**Official Transcript of Proceedings**  
**NUCLEAR REGULATORY COMMISSION**

Title:               Advisory Committee on Reactor Safeguards  
                      Regulatory Policies and Practices  
                      Subcommittee

Date:                February 24, 2017

The purpose of today's meeting is for the NRC staff to discuss the draft final Regulatory Guide 4.25, Assessment of Abnormal Radionuclide Discharges in Ground Water to Unrestricted Area at Nuclear Power Plant Sites.

# Appendix Model Background: Subdividing Monitoring Wells Transect into Modeling Blocks

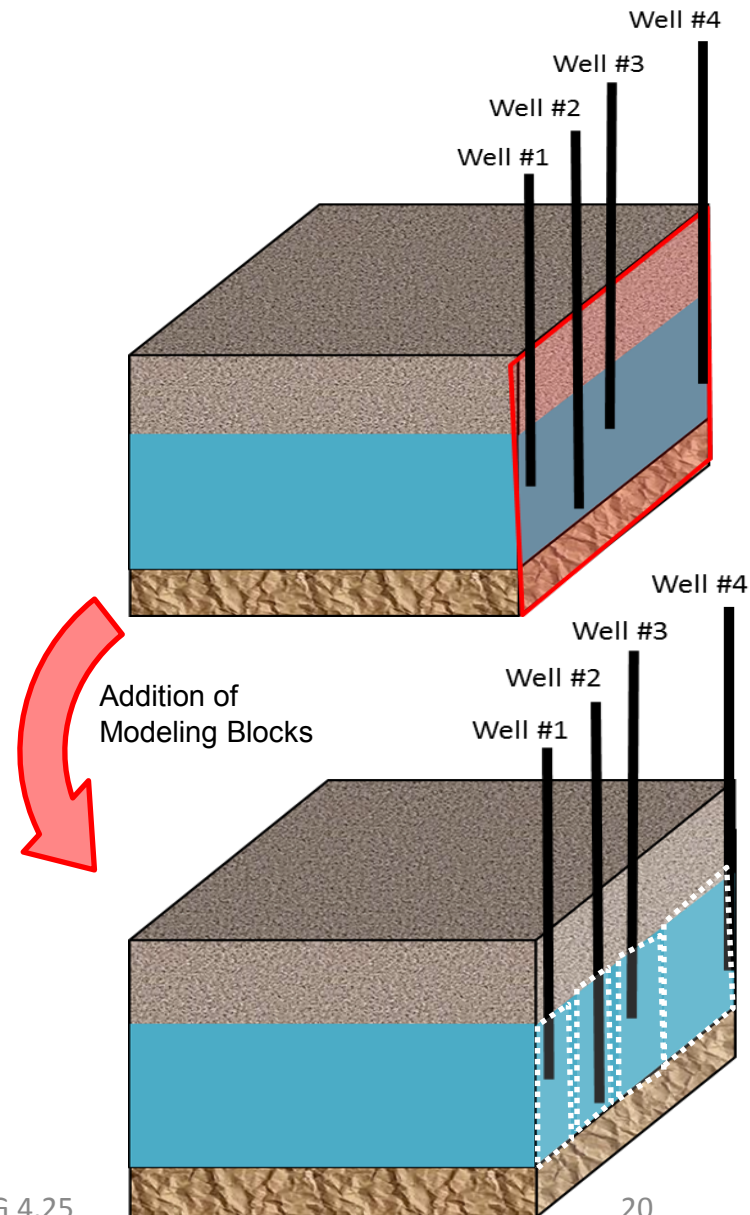
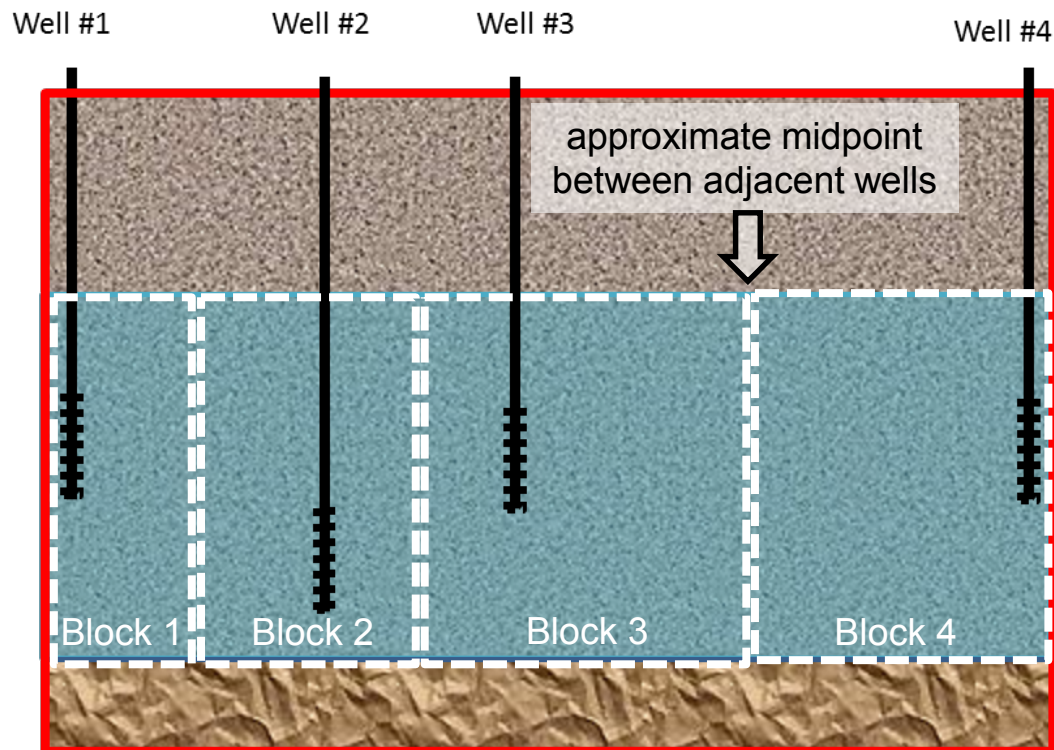
CHAIR SUNSERI: So I am looking at this slide here and I just have a question. I am not a modeler. But it would seem to me, I mean, it's portraying three different models.

MEMBER POWERS: On the previous figure why wouldn't you take three blocks? What boundary is coinciding with the wells?

So the modeling blocks themselves vary in size based on how many monitoring levels you have across the transect. My best explanation I can give you at the moment.

The illustration on the right - the two-figure illustration shows the modeling blocks in relation to the 3D model. So taking that transect on the left and imposing it back onto the model in the lower right hand corner.
